**TOTAL SUSPENDED SOLIDS TOTAL MAXIMUM
DAILY LOAD EVALUATION FOR CHOTEAU
CREEK, BON HOMME AND CHARLES MIX
COUNTIES, SOUTH DAKOTA**

**SOUTH DAKOTA DEPARTMENT OF
ENVIRONMENT AND NATURAL RESOURCES**

FEBRUARY, 2010

This document provides a standard format for EPA Region 8 to provide comments to state TMDL programs on TMDL documents submitted to EPA for either formal or informal review. All TMDL documents are evaluated against the minimum submission requirements and TMDL elements identified in the following 8 sections:

Figure 5. Choteau Creek Load Duration Curve for Total Suspended Solids

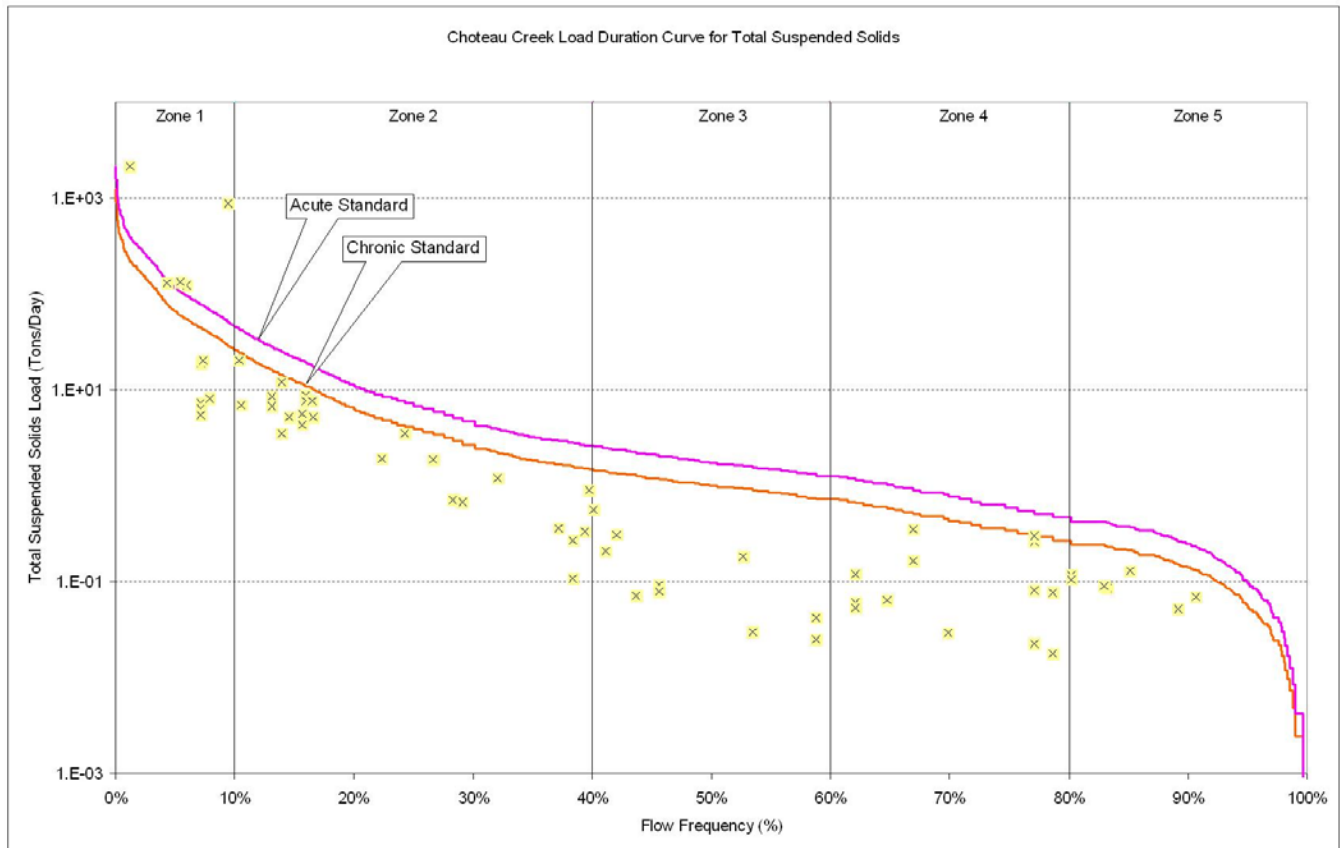
South Dakota's water quality standards do not apply when the flow in stream designated as a low quality fishery (marginal and semi permanent warmwater fisheries), is below the 7 day average low flow that can be expected to occur once in five years (7Q5) or 1.0 cubic foot per second, whichever is greater. Choteau Creek is designated as a semi permanent fishery, so this provision applies. A flow of 1 cfs was used as the cutoff for Choteau Creek because the 7Q5 flow is equal to approximately 0.25 cfs. Therefore, loads were not calculated for the lowest flow zone (i.e., Figure 5, Zone 5 in the document) in the TMDL.
